Office Action Summary

09/881,909

Wisniewski et al.

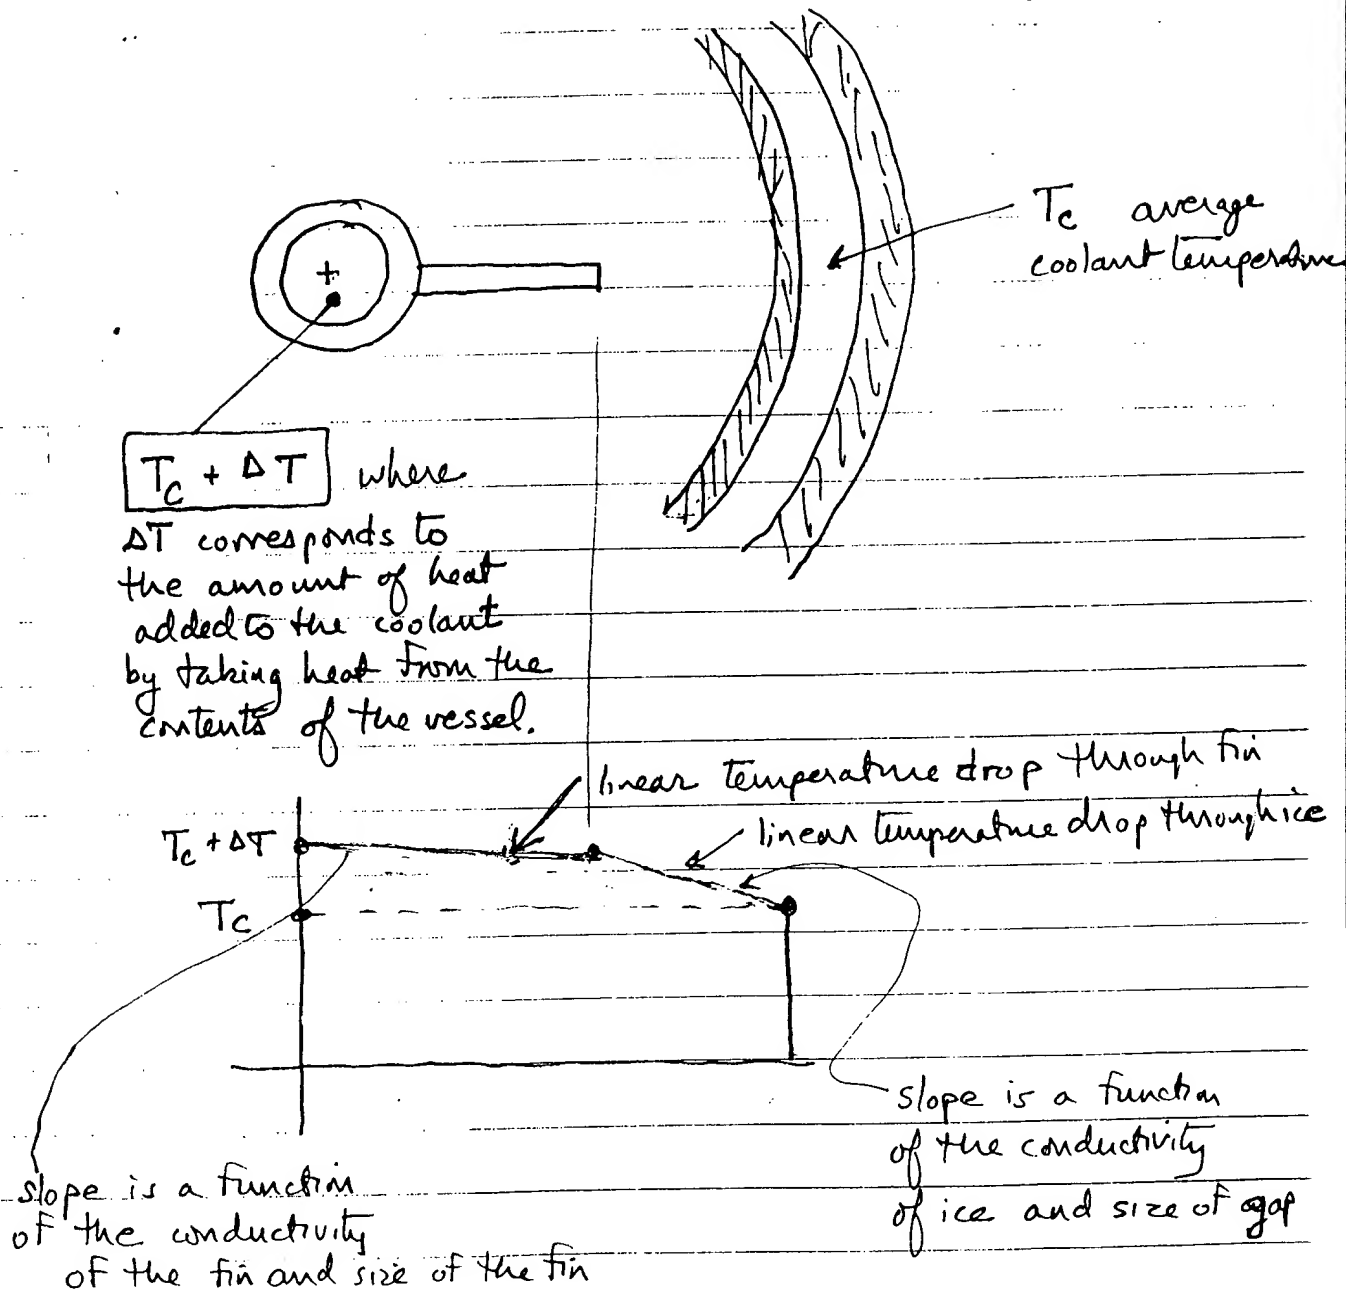
For this reason the Examiner does not find Mr. Wisniewski's thought experiments as credible evidence of what the actual temperatures are in the 1992 Genentech device. The Examiner has repeatedly asked Mr. Wisniewski to test this prior art, or a reasonable facsimile of it, using temperature transducers and Mr. Wisniewski has refused thus far.

Moreover, Exhibit B incorrectly assumes the temperature in the pipe is the same as the temperature in the jacket. This is an incorrect assumption and will necessarily lead to inaccurate conclusions. The temperature in the pipe is a complex function of the initial temperature of the coolant before it passes through the jacket, the temperature of the liquid in the container and the flow rate of the coolant among other variables. As explained above, and as shown in Figure 1 (page 134) of the 1992 article, the coolant goes from the refrigeration system to the jacket and only after exchanging heat with the contents of the vessel (and thereby acquiring some higher temperature) does it pass into the central structure where it necessarily must have a higher temperature than the

coolant in the jacket. Thus, Mr. Wisniewski's thought experiments are flawed because they are based on incorrect boundary conditions.

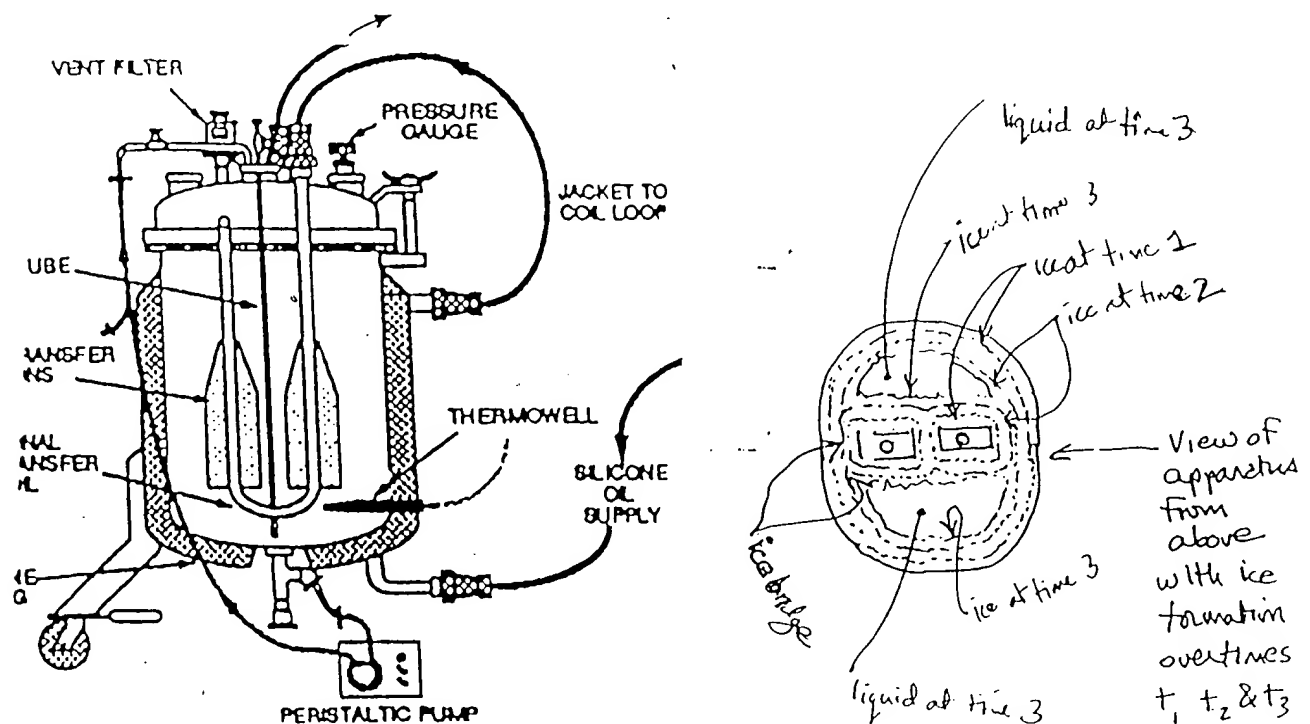
The thermal bridge of ice will inherently form between the tip of the heat transfer fins and the interior of the container because they are the closest points to one another and both are actively cooled by circulating cooled silicon oil. Closely spaced cooled surfaces are known by those of skill in the refrigeration art to form ice bridges when a liquid is being frozen into a solid.

It is evident that ice will build upon the heat exchanger and walls of the vessel shown in Figure 1 of 1992 Wisniewski and Wu research paper, during the freezing phase, until they bridge as shown in the diagrams below, a fact that can be established by basic scientific principles. Burroughs et al. USP 3,318,105 illustrates the phenomena. As is clearly seen in Figs. 1A-1C ice builds up evenly cooled surfaces and even as the top surface freezes the ice coating on the submerged surfaces continues to build up more or less evenly. The same type of analysis is disclosed by Finnegan USP 2,129,572, illustrating that the time required to freeze a substance varies "approximately as the square of the thickness of such substance" with slower freezing generally leading to undesirable concentration effects (what applicants and the 1992 Wisniewski and Wu research paper refer to as "cryoconcentration"). Finnegan, like the 1992 Wisniewski and Wu research paper, discloses the use of heat exchange fins (projecting inwardly from the exterior wall of the container in the case of Finnegan) to form compartments within the tank to speed the freezing process. Finnegan illustrates using a series of dotted lines how the freezing process progresses over time in various geometries of

heat exchange fins. Applying this same science (illustrated by Burroughs and Finnegan) to the system disclosed by 1992 Wisniewski and Wu research paper yield the results illustrated on the next page for the system disclosed by the 1992 Wisniewski and Wu research paper in Figure 1.
